Re: PETITION NO. 1310 – Quinebaug Solar, LLC Petition for Declaratory Ruling

Enclosed please find an original and 15 copies of Quinebaug Solar, LLC's responses to the Connecticut Siting Council's ("Council's") interrogatories CSC-1 through CSC-77 in connection with the above-referenced matter.

**STATE OF CONNECTICUT
CONNECTICUT SITING COUNCIL**

Petition No. 1310

Quinebaug Solar
Brooklyn & Canterbury,
Connecticut

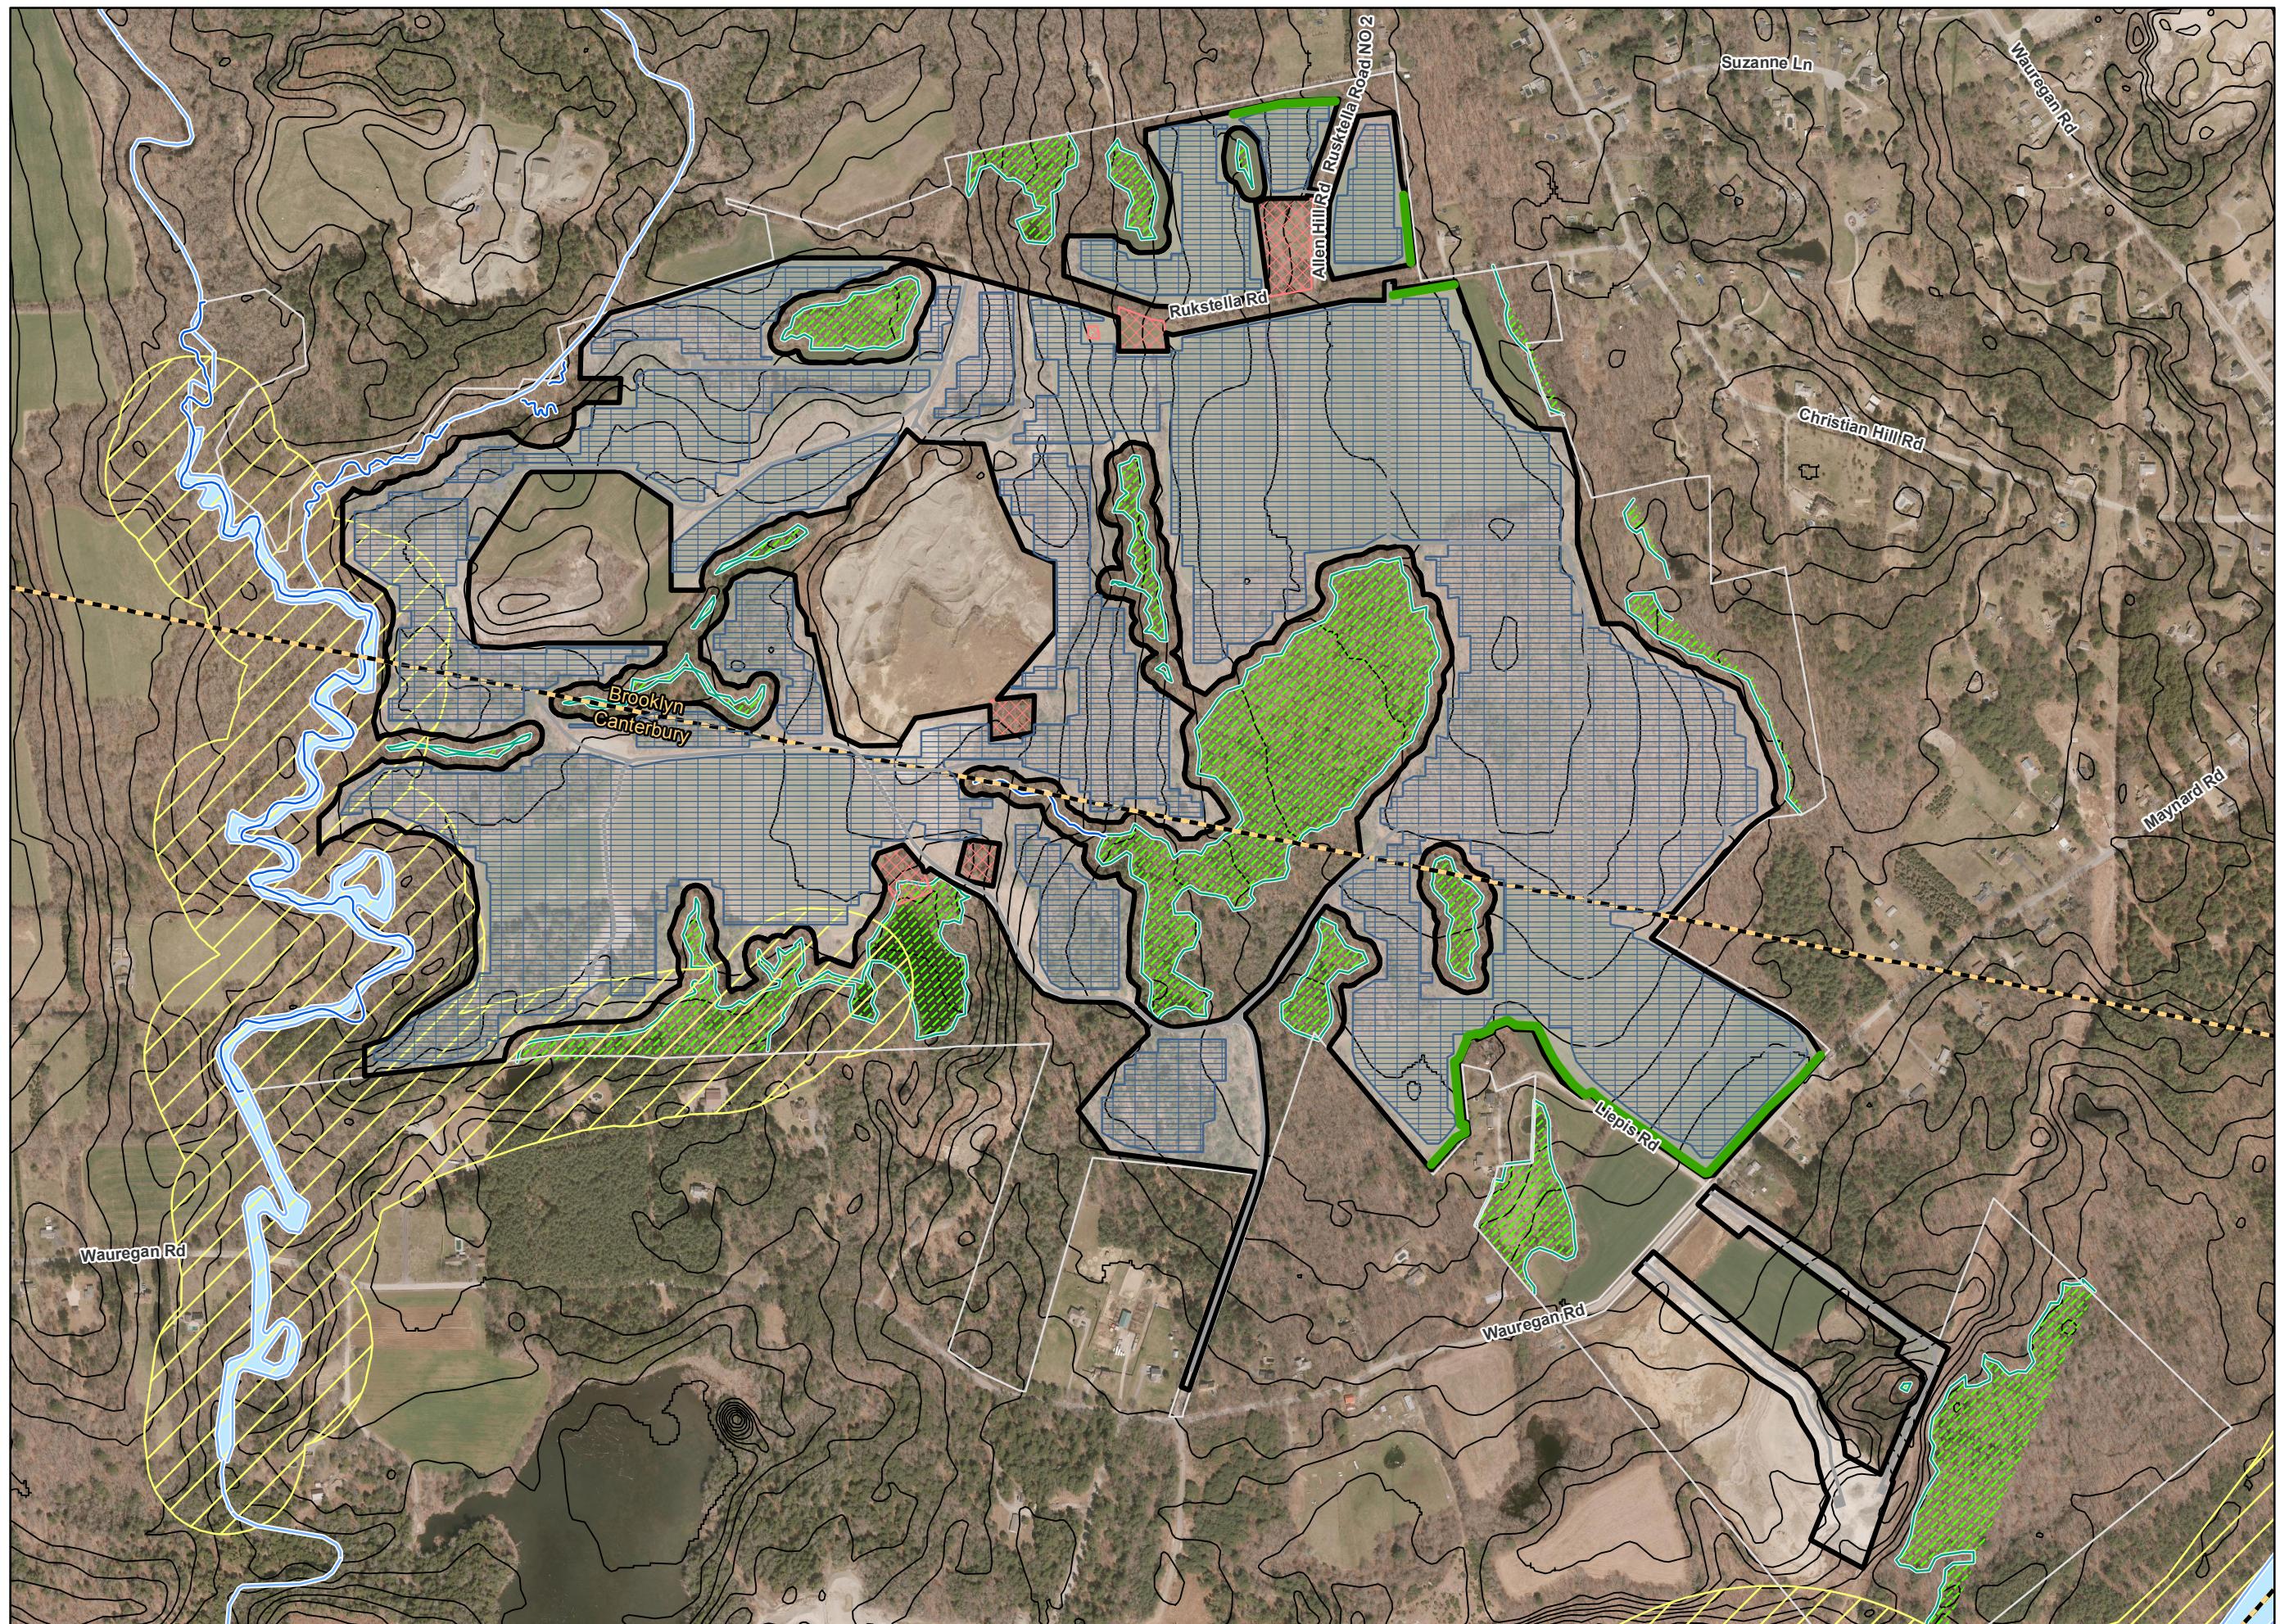
**CSC-42 Would glare from the panels present a problem for any nearby properties?
Can plantings be used to buffer the visibility of and/or glare from the solar arrays?**

Quinebaug has proposed to increase the vegetative screening associated with the project, in direct response to ongoing abutter outreach. Please refer to the updated proposed conditions figure in Exhibit CSC-42 – Updated Proposed Conditions Figure.

Exhibit CSC-56
Ground Water Figure

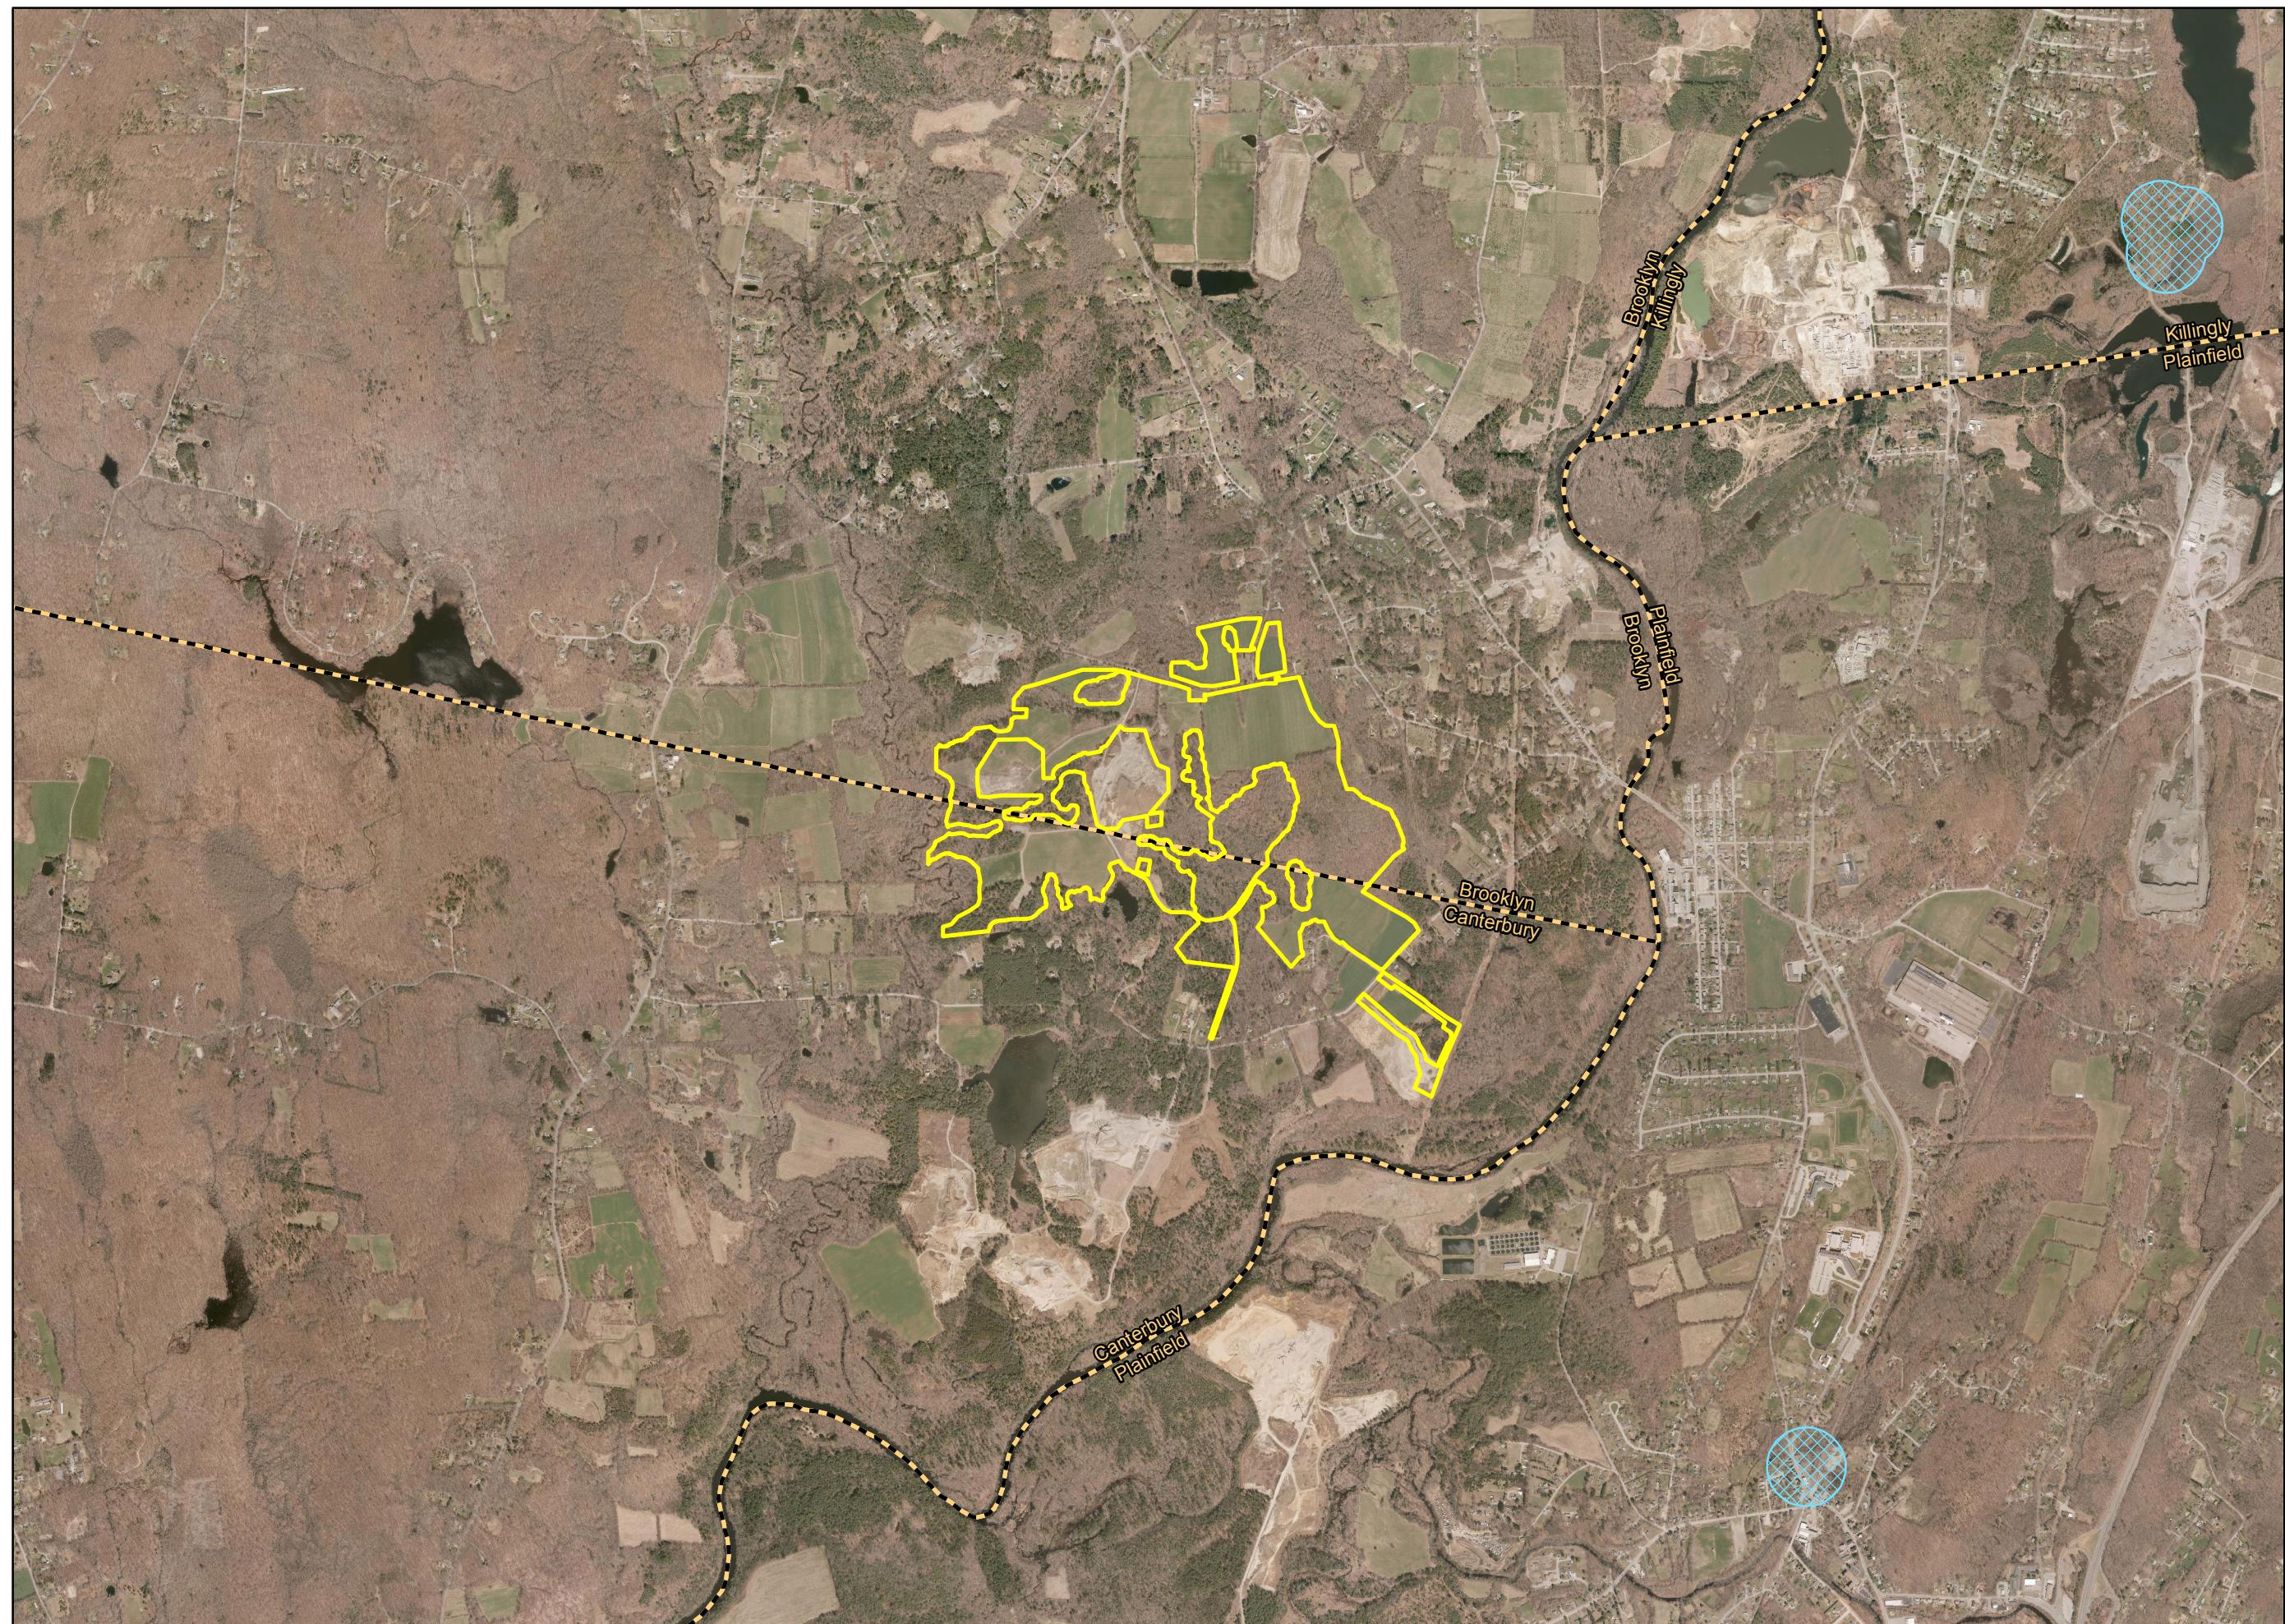
CSC-56 Is it correct to say that the proposed project would not be located within a DEEP-designated aquifer protection area? Are there any wells on the site or in the vicinity of the site? If so, how would the petitioner protect the wells and/or water quality from construction impacts.

Petitioner's Response: As shown on the Existing Conditions figure provided in Exhibit B of the Petition, the proposed project will not be located within a DEEP-designated aquifer protection area, and there are no aquifer protection areas mapped in the vicinity of the Project site. The Figure in Exhibit CSC-56 – Ground Water Figure shows that the Project site is not located in proximity to the Area of Contribution to a Public Water Supply Well.

Exhibit CSC-57

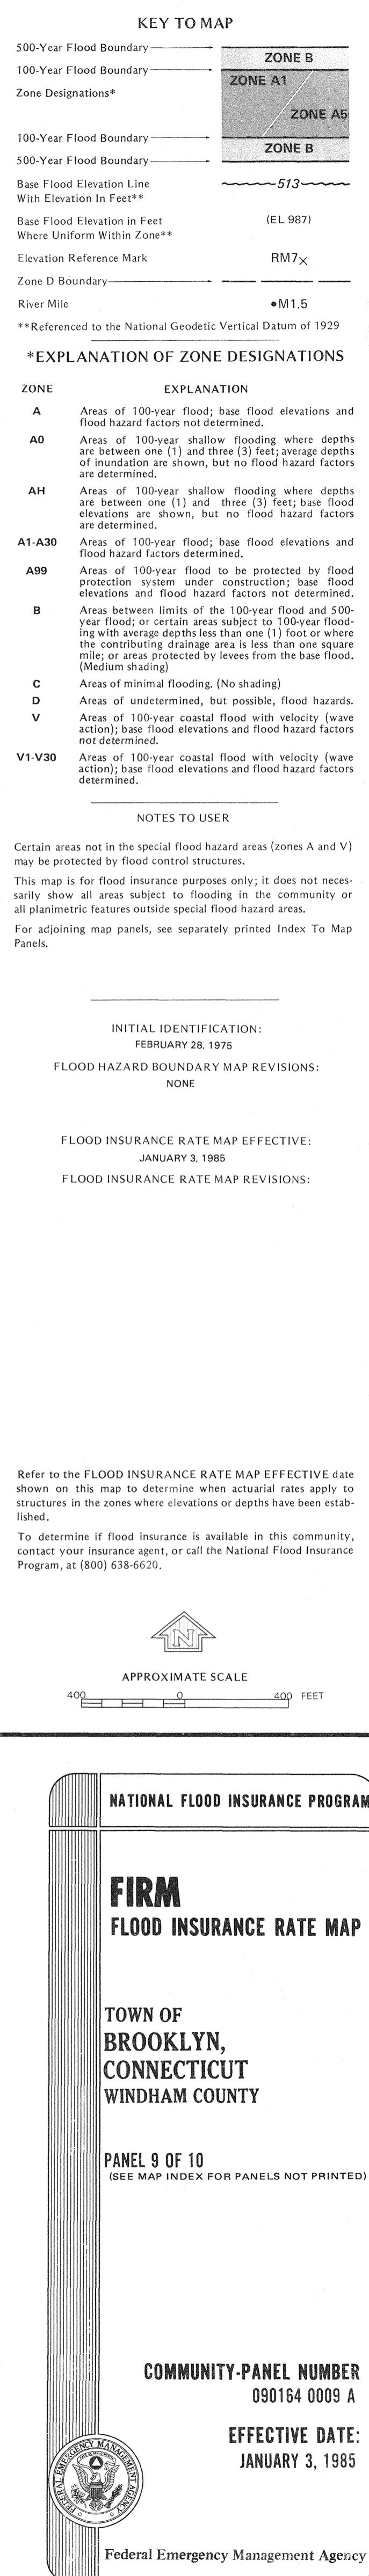
**CSC-57 Is any portion of the proposed project located within a 500-year flood zone?
Provide Federal Emergency Management Agency flood zone map(s) that includes the
proposed project.**

Petitioner's Response: Small portions of the site are located within a 500-year flood zone (FEMA Zone B). Please refer to the attached Flood Rate Insurance Maps (Town of Brooklyn Panels 0901640003A, 0901640008A, 0901640009A, and Town of Canterbury Panel 0901830010A) in Exhibit CSC-57 – FEMA Maps.
